Clarifications related to Clause 119 PCS restart_lock

IEEE 802.3 Maintenance Task Force Meeting
Virtual Teleconference
September 2021

Overview

P802.3/D2.0 119.2.6.3 State diagrams – Current Text

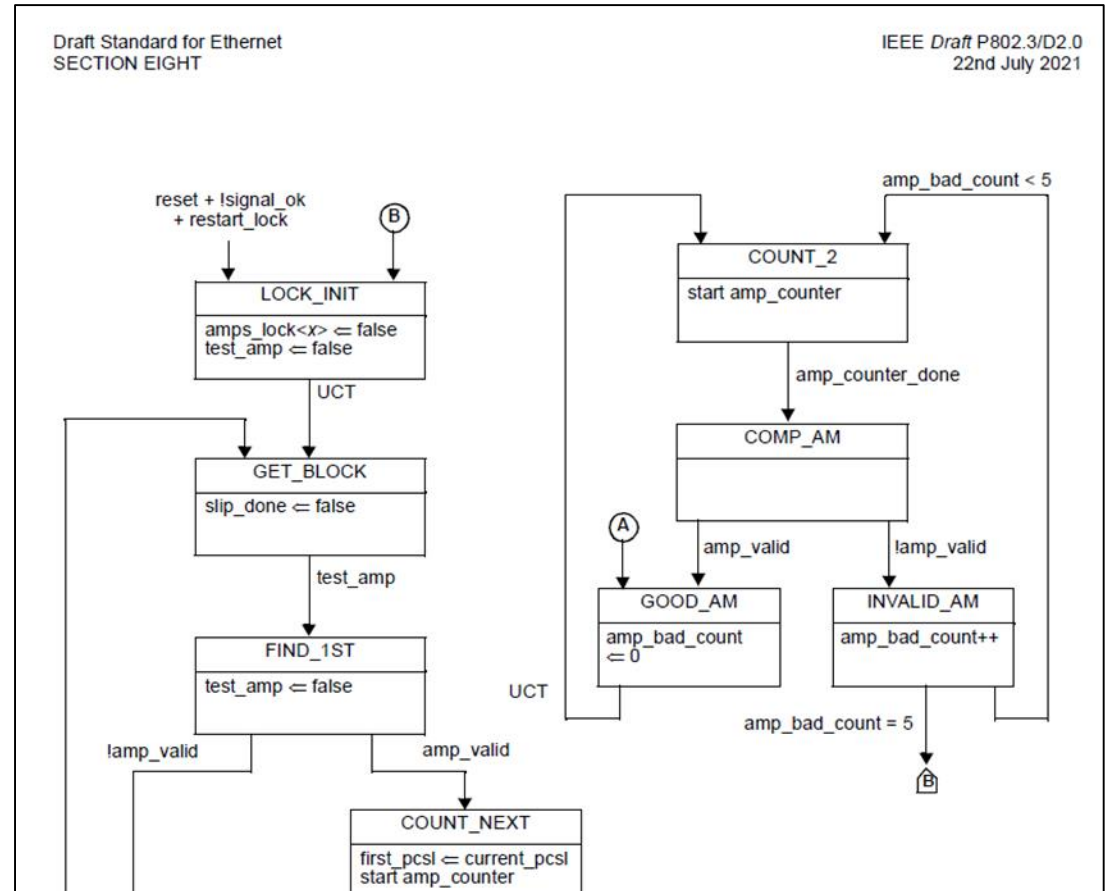
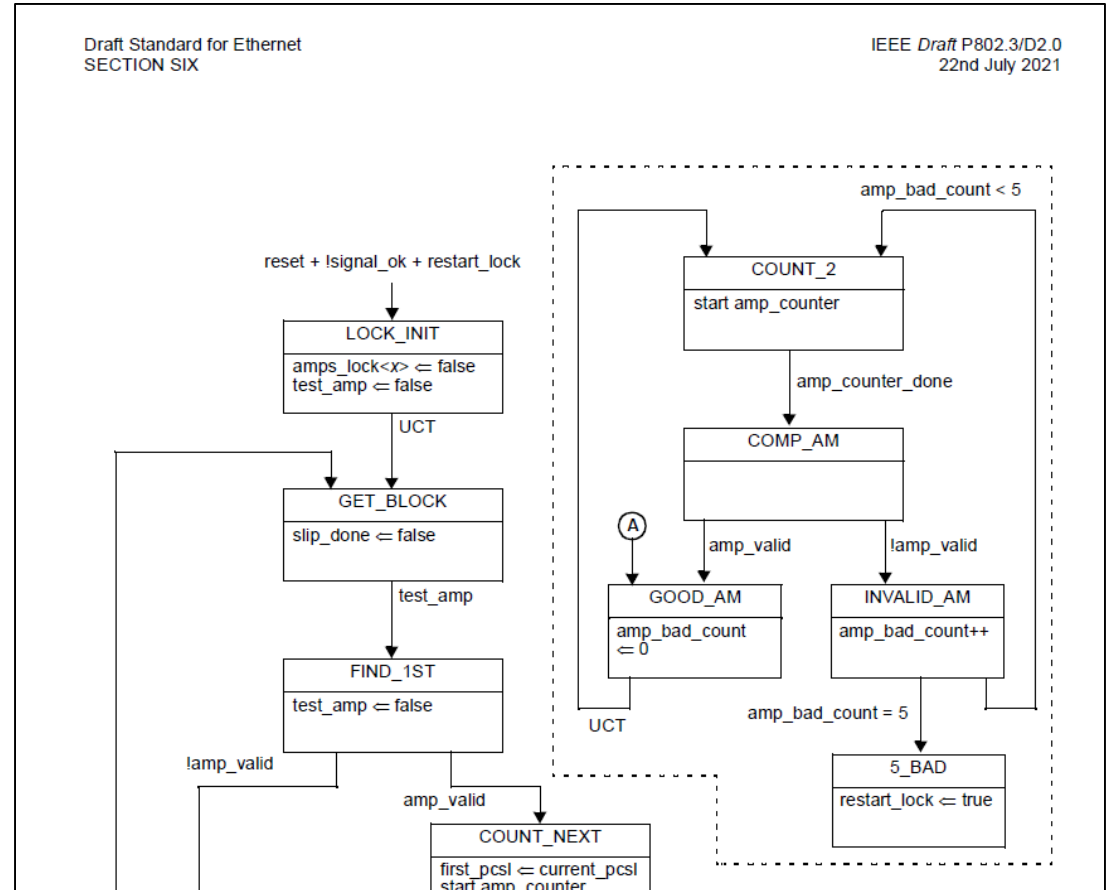
- **Text description (highlighted) of 119.2.6.3 states that restart_lock is signaled in either of following conditions:**
 - When the PCS synchronization process determines that three uncorrectable codewords in a row are seen
 - When the alignment marker lock process sees five alignment markers in a row that fail to match the expected pattern on a given lane
- **Based on state diagrams (next slide) only one of these conditions still impacts restart_lock**
 - The other condition is historical text that pre-dates the state diagram change that appeared in P802.3bs/D3.3 Figure 119-12 – Alignment marker lock state diagram

- **Propose to modify portion of the text**
 - Encapsulate within parenthesis (see highlighted text) the single condition that affects restart_lock

The 200GBASE-R PCS shall implement eight alignment marker lock processes and the 400GBASE-R PCS shall implement sixteen alignment marker lock processes as depicted in Figure 119-12. An alignment marker lock process operates independently on each lane. The alignment marker lock state diagram shown in Figure 119-12 determines when the PCS has obtained alignment marker lock to the received bit stream for a given lane of the service interface. Each alignment marker lock process looks for two valid alignment markers $2^{78} 528 \times 10$ -bit Reed-Solomon symbols apart, on a per PCS lane basis, to gain alignment marker lock. When the alignment marker lock process achieves lock for a lane, and if a Clause 45 MDIO is implemented, the PCS shall record the PCS lane number received on that lane of the service interface in the appropriate lane mapping register (3.400 to 3.415). Once in lock, a lane goes out of alignment marker lock when restart_lock is signaled (this occurs when the PCS synchronization process determines that three uncorrectable codewords in a row are seen) or when the alignment marker lock process sees five alignment markers in a row that fail to match the expected pattern on a given lane.
